NAC INTERNATIONAL

Subject: Docket No. 71-9270 (TAC No. L22452)

Submittal of the NAC Responses to the NRC Request for Additional Information (RAI) on the UMS® Universal Transport Cask Application, Chapter 2 Structural Evaluation

Figure 2.50-1 Typical Filtered Acceleration (Top Accelerometer) Time History for the Quarter-Scale Model Side Drop, Overlayed with the Unfiltered Data

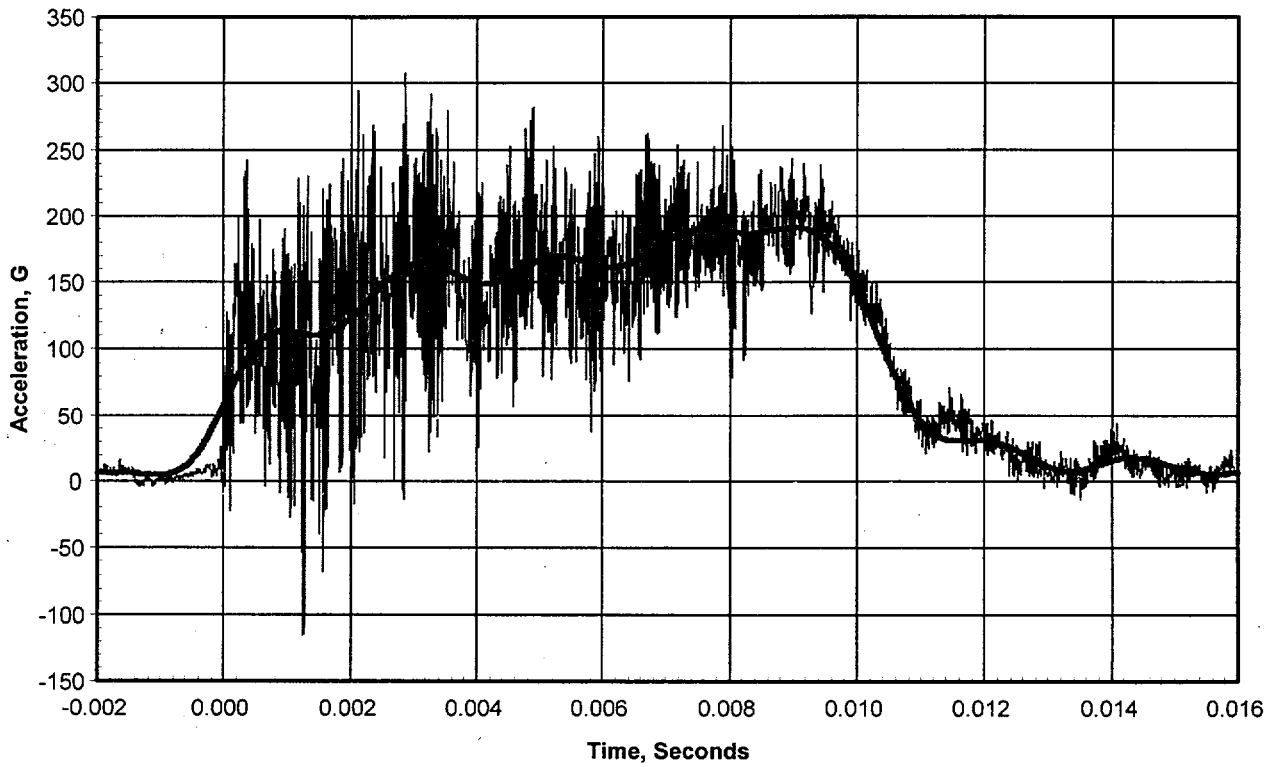
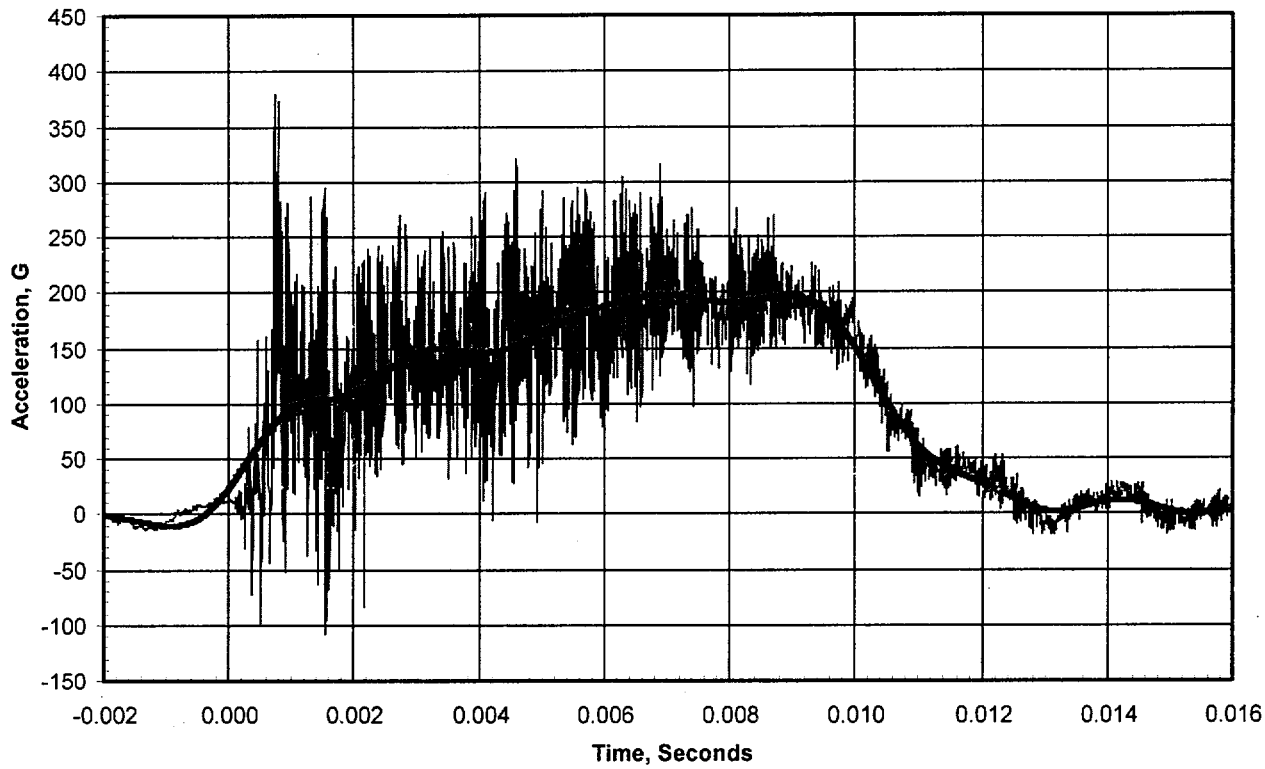
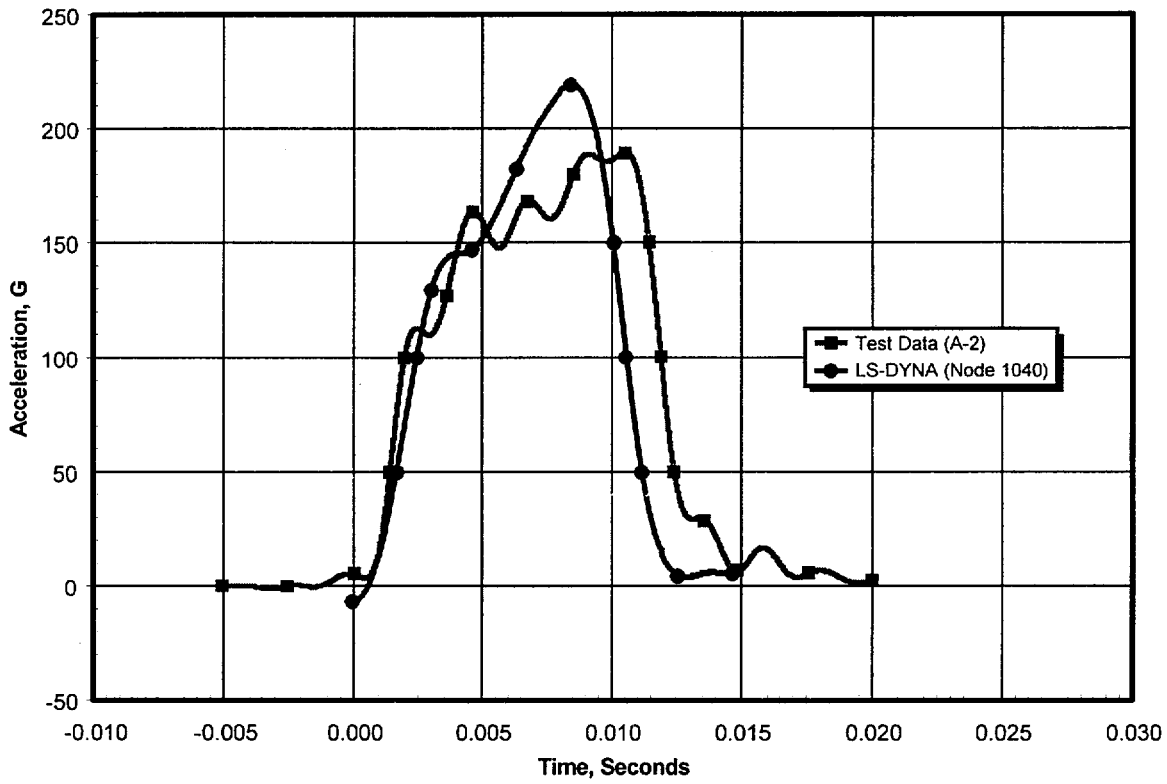
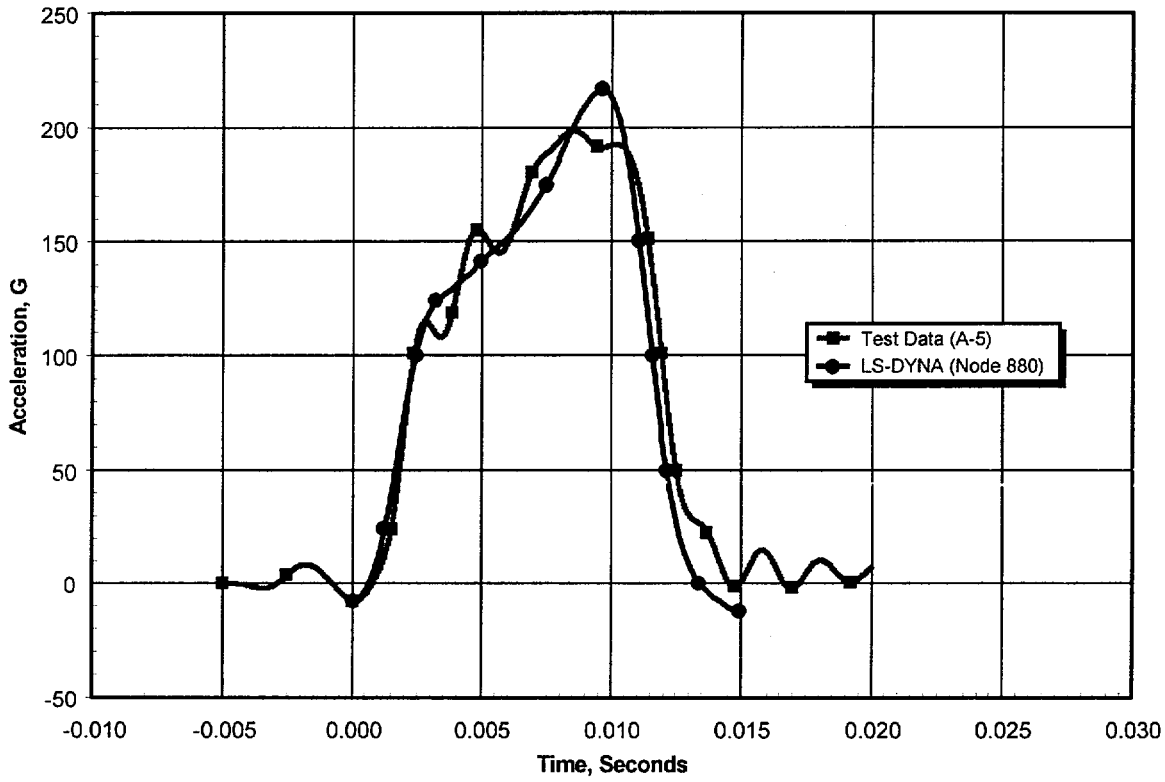
2. The measured acceleration time history in Figure 2.10.3-6 suggests significant cask rocking, which is uncharacteristic of a Universal Transport Cask undergoing side-drop response.

2. A side drop test performed at Sandia National Laboratory on March 13, 2001, showed none of the uncharacteristic rocking response noted during the Oak Ridge side drop test. Figures 2.50-1 through 2.50-4 of this response show the filtered and unfiltered test results and compare the LS-DYNA analysis prediction to side drop test data. These results and details of the Sandia test have been added to Section 2.10.3.7.
